Re: Garvies Point – PUD Master Development Plan Amendment Review
and Blocks D, E & F Site Plan Review, Response to Cleary Consulting Memo Dated 04/15/2021

This letter will serve as a response to the 04/15/2021 memo provided by Cleary Consulting regarding the PUD Master Plan Amendment and Blocks D, E, & F Site Plan Submission.

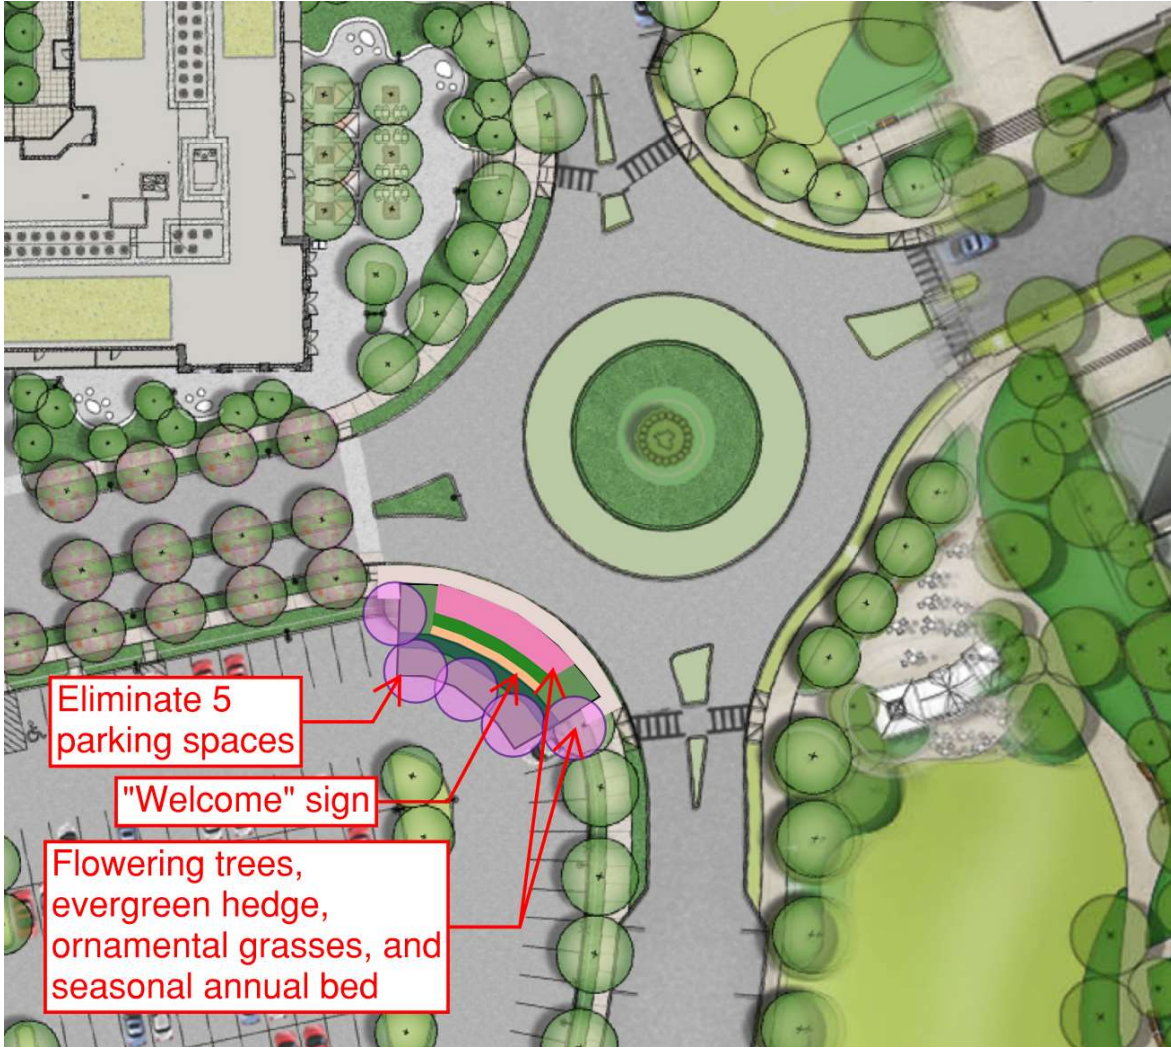
Concern still exists regarding the loss of the visual anchor that the office building provided at the rotary. The Applicant has noted that views would now be unobstructed and street trees are proposed. While views would indeed be unobstructed, they would occur across a parking lot – a feature generally considered to be unattractive. The Applicant has clarified the proposed landscaping; however, the narrow right-of-way and configuration of the parking lot severely limits the available area to bolster the landscaping and enhance the appearance of this area.

The aesthetic importance of this area cannot be overstated. The roundabout is a key feature, and a perceptual gateway, and while 3 of its corners are well treated, the parking lot is visually a concern. The Applicant should evaluate whether additional landscaping can be installed without sacrificing parking spaces.

For example, can the first 5 or so parking spaces at the northeast corner of the parking lot, adjacent to the southwest corner of the rotary, be reclaimed to create an approximately 1,000 square foot landscaped design element, to not only screen the parking lot from the direct sightline as one travels around the rotary, but also serve as a welcoming gateway to the balance of the development?

In response to the discussion held with SA and the City on 05/07/21, five parking spaces are proposed to be replaced with a sign and plantings at the NE corner of Block D. This signage and landscaping element will accomplish several goals: it will provide a new visual element to anchor the 4th corner of this roundabout intersection; will complement the other features on the remaining 3 corners; will identify the Garvies name at a prominent location within Garvies Point; and will create a new beautiful feature that will screen the parking lot.

This will be further detailed in a revised submission. See below for a diagrammatic concept.

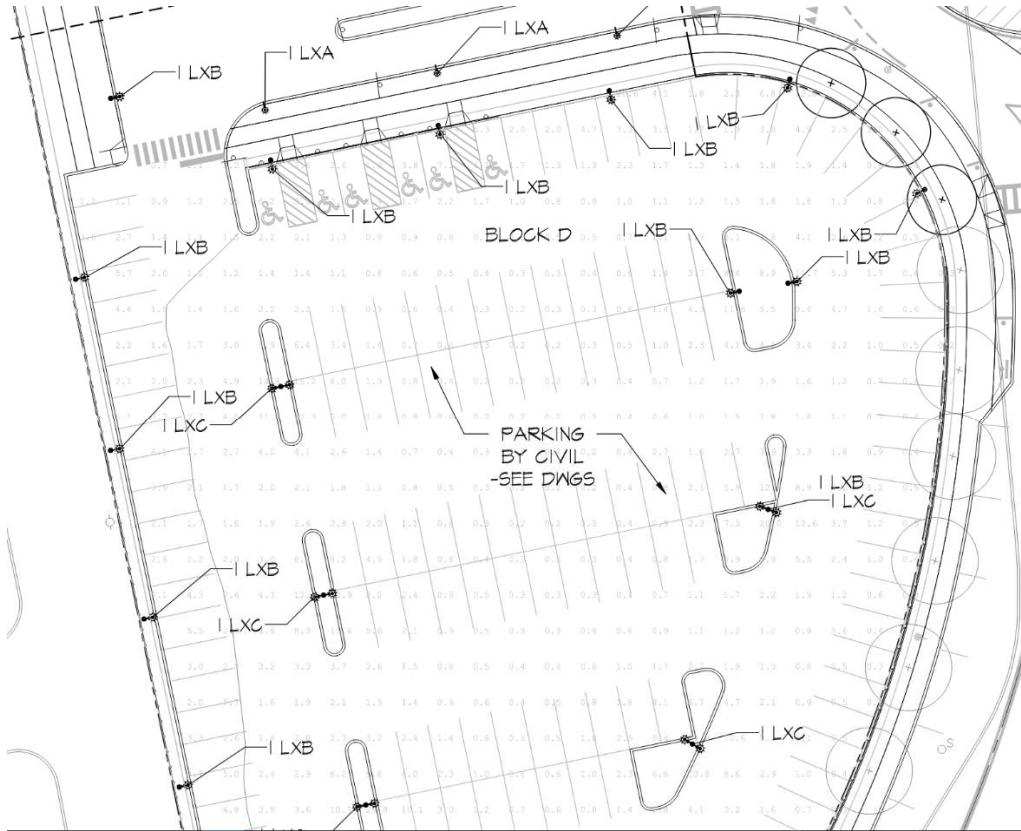
The Applicant has indicated that photometric details have been added to the lighting plans as requested. However, while a note in the legend indicates foot candle isolines, they do not appear on the drawings. Clarification is required.

Photometrics have been previously provided. Refer to sheets L-307 & L-308. Screenshots below provided for additional reference.
